REMEDIATION SYSTEM EVALUATION

OTT/STORY/CORDOVA SUPERFUND SITE DALTON TOWNSHIP, MUSKEGON COUNTY, MICHIGAN

Report of the Remediation System Evaluation,
Site Visit Conducted at the Ott/Story/Cordova Superfund Site
September 27-28, 2001

Final Report Submitted to Region 5
March 12, 2002

FIGURE 1-1. SITE LAYOUT OF THE OTT/STORY/CORDOVA SUPERFUND SITE INDICATING SAMPLING AND ANALYSIS RESULTS OF THE UPPER PORTION OF THE UNCONFINED AQUIFER FROM THE MARCH 2001 SAMPLING EVENT.

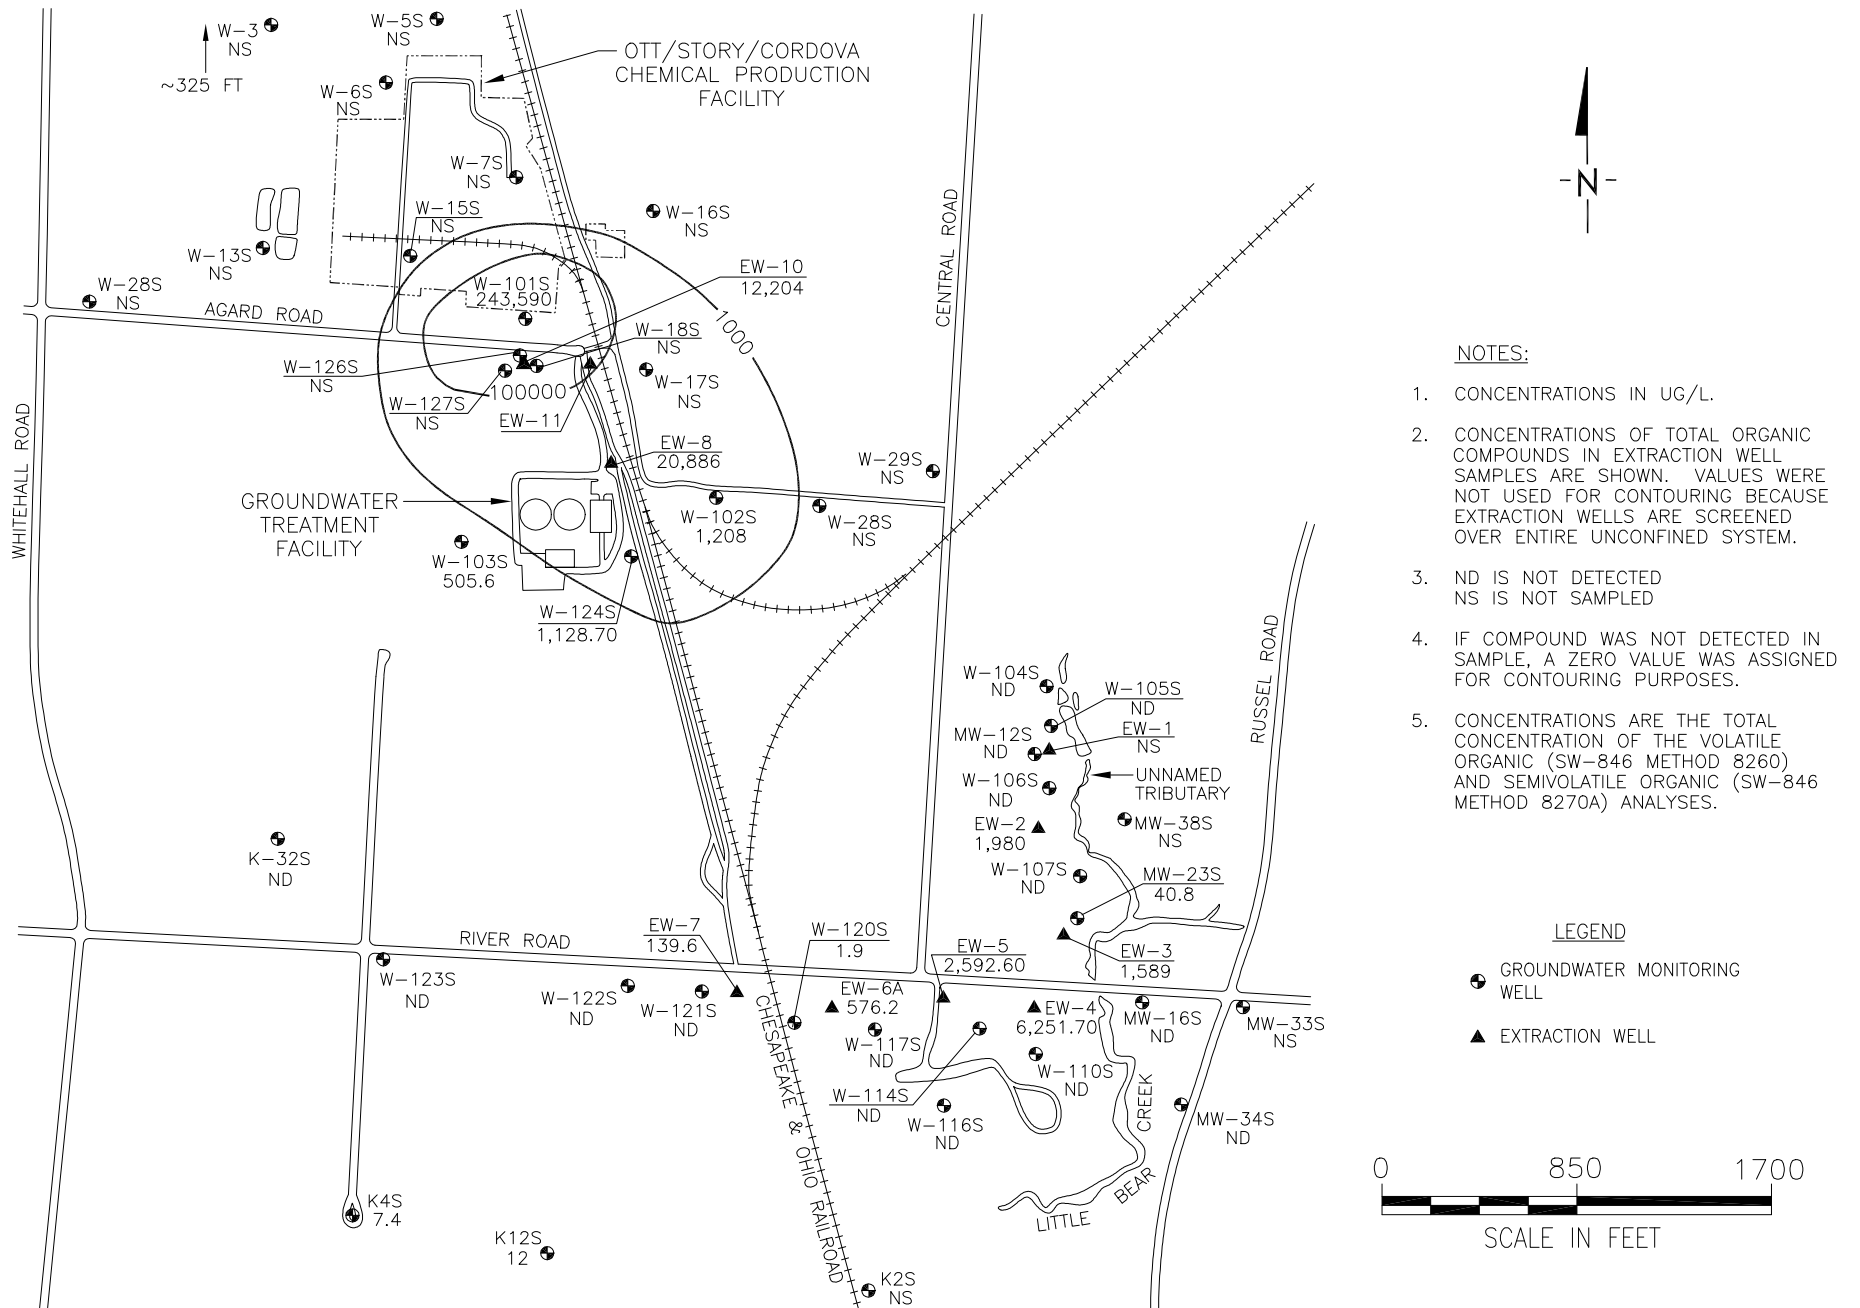
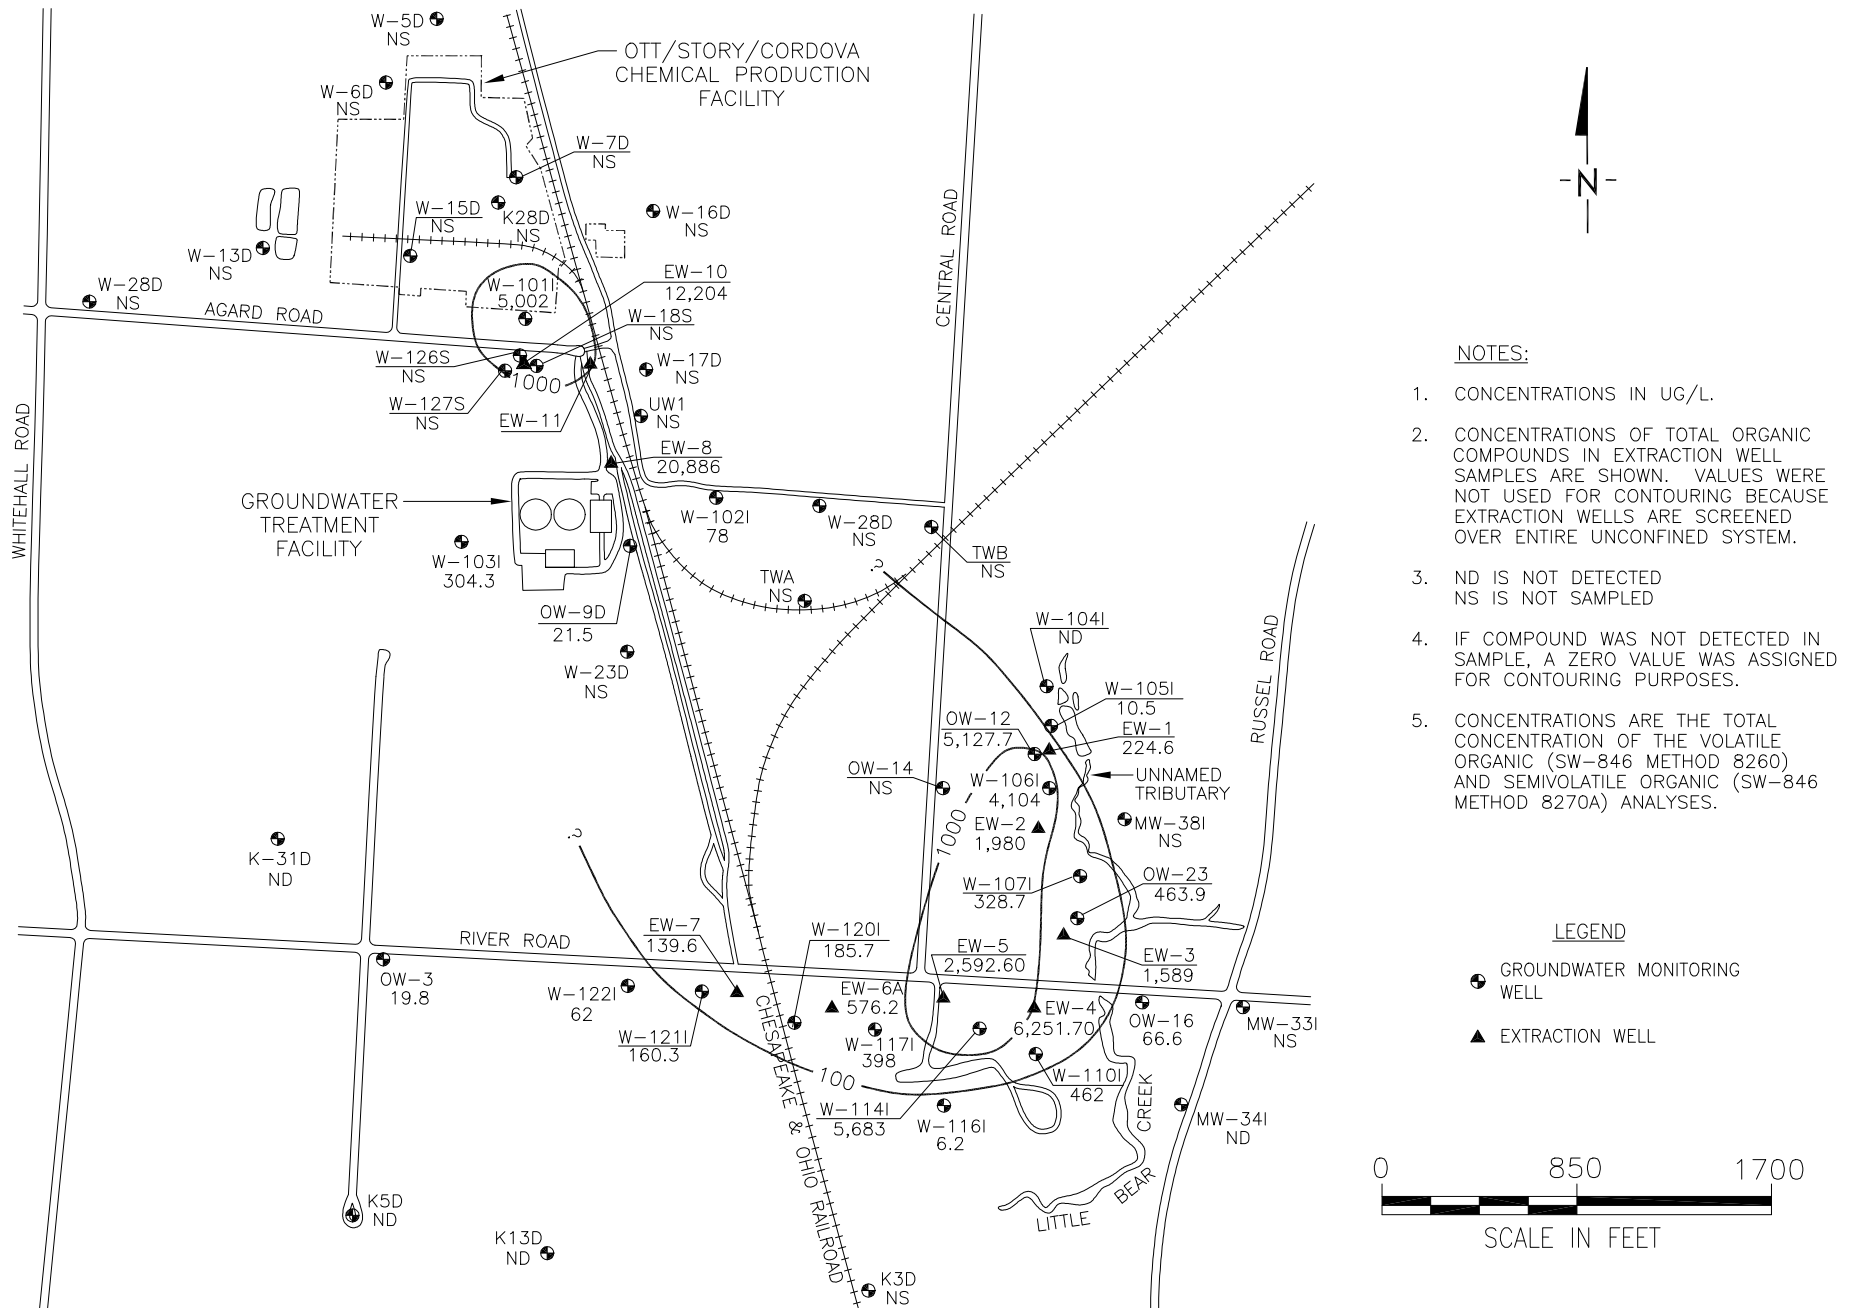
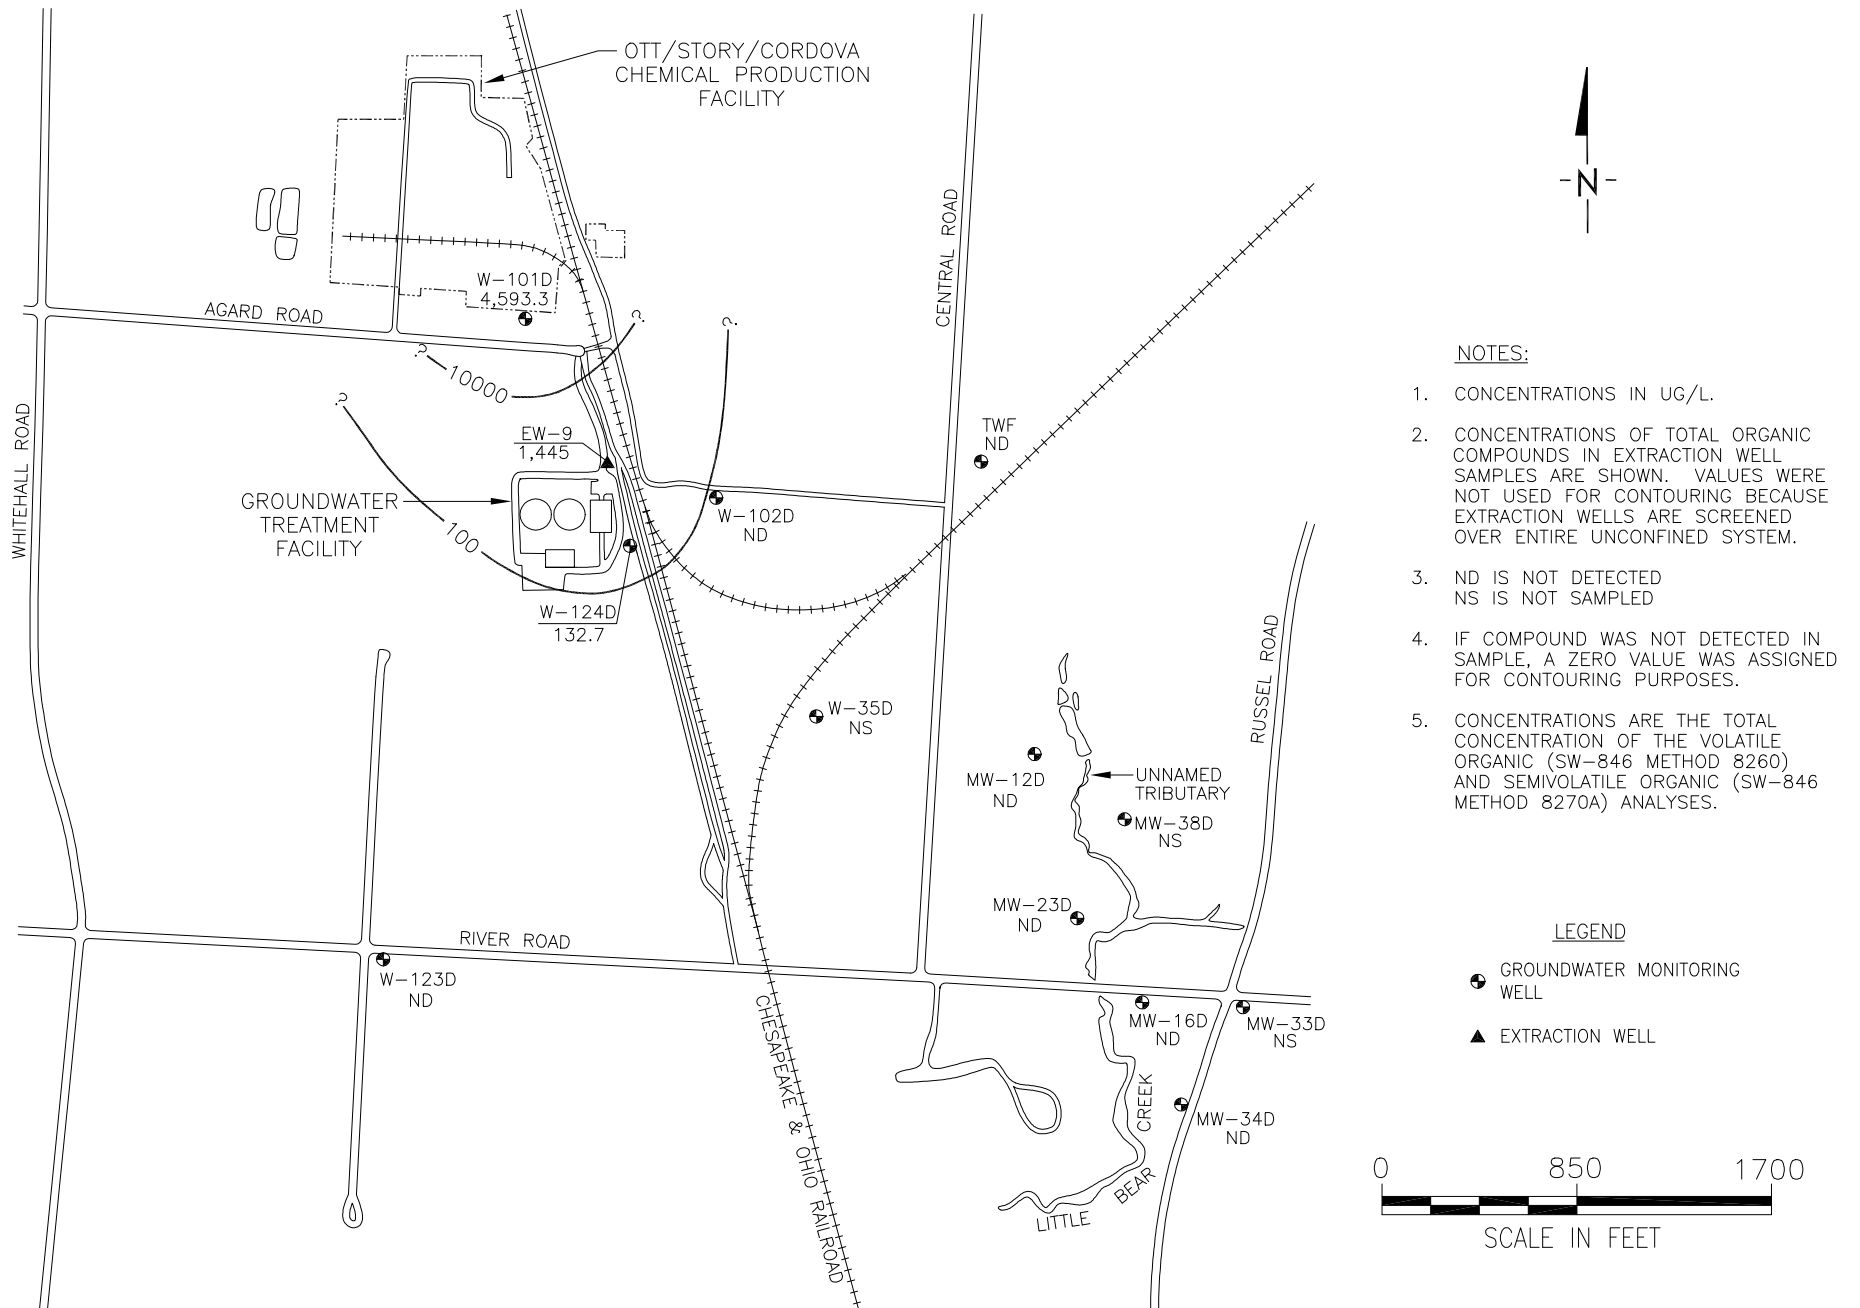
The extraction wells comprising the current extraction system are indicated in Figures 1-1 through 1-3. All wells screen the majority of the unconfined aquifer with the exception of EW-9, which screens the semi-confined aquifer. The 10 installed wells have a total design extraction rate of 800 gpm, and EW-11 will have a design flow rate of 40 gpm (although preliminary pump tests suggest it may be capable of extracting at a flow rate of 100 gpm). The extraction system typically operates at or above 700 gpm. A double-walled collection system with a leak detection system transports the water from the extraction wells to the treatment plant through four mains that combine into one prior to entering the plant. The extraction wells have rehabilitation wells installed adjacent to them, and a comprehensive well-maintenance program for ensuring the integrity of the extraction wells.

FIGURE 2-1. SITE LAYOUT OF THE OTT/STORY/CORDOVA SUPERFUND SITE INDICATING SAMPLING AND ANALYSIS RESULTS OF THE UPPER PORTION OF THE UNCONFINED AQUIFER FROM THE MARCH 2001 SAMPLING EVENT.

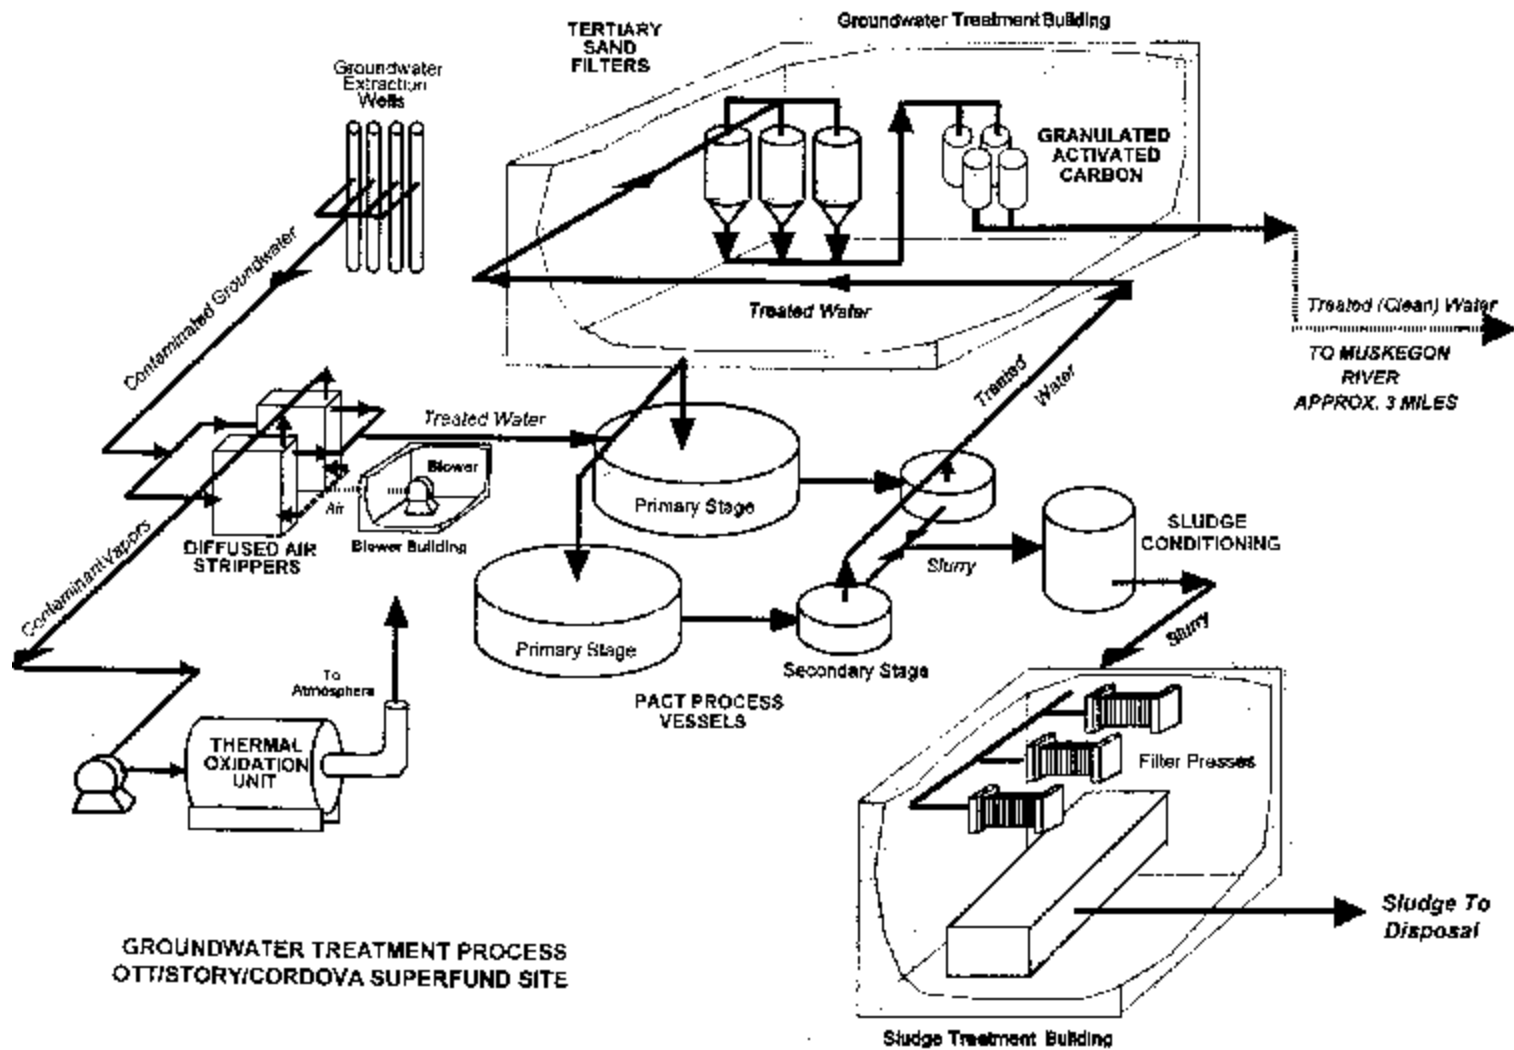
Water from the extraction system is split among two treatment trains that each consist of diffused air stripping (DAS) tanks, addition of a nutrient (phosphoric acid), two stages of aeration and clarification for biological treatment, addition of powdered activated carbon and ferric chloride, sand filtration, and liquid phase GAC. Air from the DAS units and the aeration tanks is treated in a thermal oxidation unit (TOU) before being discharged to the atmosphere. Treated water is transported through piping to a stationary aerator prior to discharge to the Muskegon River. Sludge generated from the biological systems is conditioned and then transported to filter presses before being disposed of as non-hazardous waste. As a whole, the treatment plant is designed for a flow rate of 900 gpm. A diagram of the treatment system provided by the plant operators is included as Figure 2-1.
